### **Editorial Comment Bucket**

### **Comment Bucket Buckets**

### Text in question

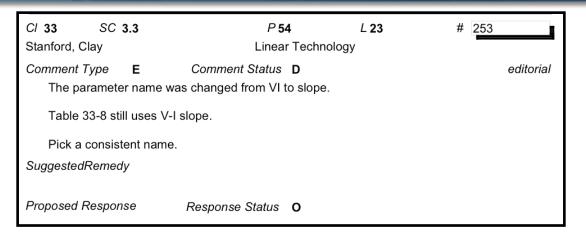
CI 33 SC 2.8 P40 L23 # 134
Schindler, Fred Cisco Systems

Comment Type E Comment Status D editorial
Consider using "k" or something other than "V" to convey that a constant is being used.

SuggestedRemedy
Suggest using "KTran\_lo."

- ◆ The usage of 'V' implies a voltage, whereas this term is only a percentage of a voltage.
- Accept the proposed remedy and update references

1			1				
	2a	Voltage transient below V <sub>Port</sub> min	K <sub>Tran_lo</sub>	%	7.6	2	See 33.2.8.2b

Parameter name was changed to better fit equation formatting requirements.

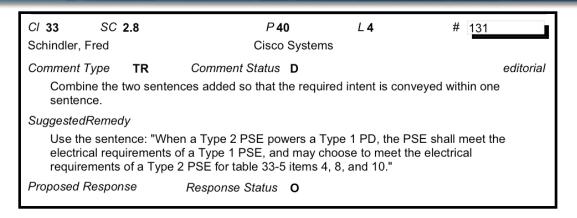
V-I slope = 
$$(V_2 - V_1)/(I_2 - I_1)$$
  $\longrightarrow$   $slope = (V_2 - V_1)/(I_2 - I_1)$

- Use of "V-I slope" in Table 33-8 is informative to reader, however.
- Can change definition to clarify that slope is the V-I slope "slope is the effective resistance"

"slope is the V-I slope and effective resistance of the PD detection signature"

#### Proposed text

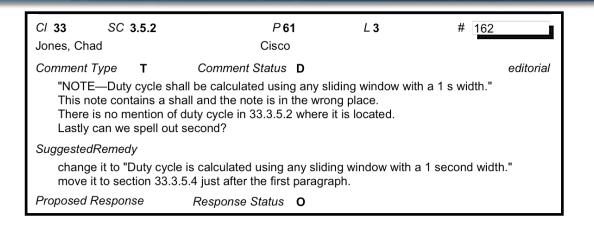
When a Type2 PSE powers a Type1 PD, the PSE shall meet the electrical requirements of a Type1 PSE. Such a PSE may choose to meet the electrical requirements of a Type2 PSE for Table 33-5 items 4, 8, and 10.

- ➤ When a Type2 PSE powers a Type1 PD, the PSE shall meet the electrical requirements of a Type1 PSE and may choose to meet the electrical requirements of a Type2 PSE for Table 33-5 items 4, 8, and 10.
- The proposed wordsmithing seems clearer and does not change the intent.

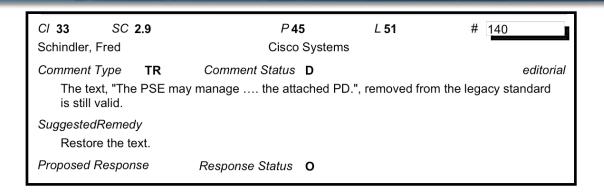
- This NOTE came about from D0.9/#192.
- ◆ 33.3.5.2 describes "input average power," which is why "duty cycle" is a non sequitur.
- "Shall" statements do not belong in a NOTE.
- Spelling out "s" as "second" can't hurt.
- Amend the NOTE to read:
  - ➤ NOTE—Average power is calculated using any sliding window with a width of 1 second.
- ◆ Still need to provide the clarification of what a duty cycle is per D0.9/#192. Suggest adding another NOTE in 33.3.5.4:
  - NOTE—The duty cycle of the peak current is calculated using any sliding window with a width of 1 second.

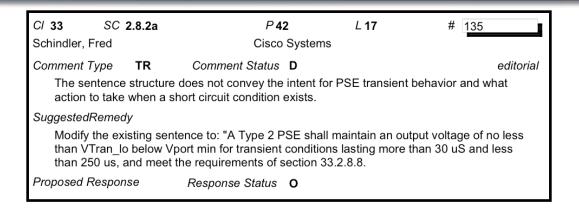
- This text was removed per D0.9/#148.
- Original text:

The PSE may manage the allocation of power based on additional information beyond the classification of the attached PD. Allocating power based on additional information about the attached PD, and the mechanism for obtaining that additional information, is beyond the scope of this standard with the exception that the allocation of power shall not be based solely on the historical data of the power consumption of the attached PD.

- The second sentence is no longer true because of DLL classification.
- The first sentence, while true, seems extraneous.
- Leave it alone (deleted) or add 1st sentence back into draft?

The PSE may manage the allocation of power based on additional information beyond the classification of the attached PD.

#### Original text:

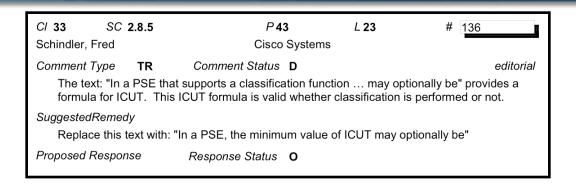
- ➤ A Type2 PSE shall maintain an output voltage no less than V<sub>Tran\_lo</sub> % below V<sub>Port</sub> min for transient conditions lasting more than 30µs and less than 250µs.
- This text does not explicitly link transient behavior with short circuit behavior.
- Proposed text:
  - ➤ A Type2 PSE shall maintain an output voltage no less than V<sub>Tran\_lo</sub> % below V<sub>Port</sub> min for transient conditions lasting more than 30µs and less than 250µs, and meet the requirements of 33.2.8.8.

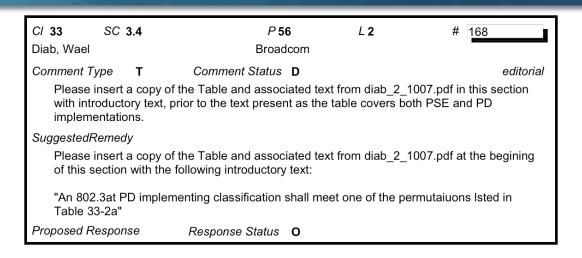
- ➤ In a PSE that supports a classification function (33.2.7 and/or 33.6), the minimum value of I<sub>CUT</sub> may optionally be P<sub>Class</sub>/Vportmin
- P<sub>Class</sub> is always defined for a PSE, regardless of whether it is Type1 or Type2, if it implements 1-Event, 2-Event, or 0-Event.
- It is therefore unnecessary to restrict I<sub>CUT</sub> scaling to PSEs implementing classification.
- ◆ This is a "may" statement, so removing the narrowing clause will not affect the installed base.
- Proposed text:
  - ➤ In a PSE, the minimum value of I<sub>CUT</sub> may optionally be...

### **Classification Comment 173**

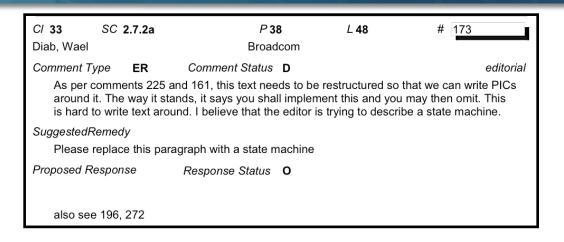
- Figure 33-7c describes the state change and decision making procedure of 2-Event classification
- 33.2.7.2a describes the same, but also has normative text referring to the details of the voltage probes
- For clarity, the text can be modified to refer to the state diagram (as the PD section does), and still maintain details on the voltage probing
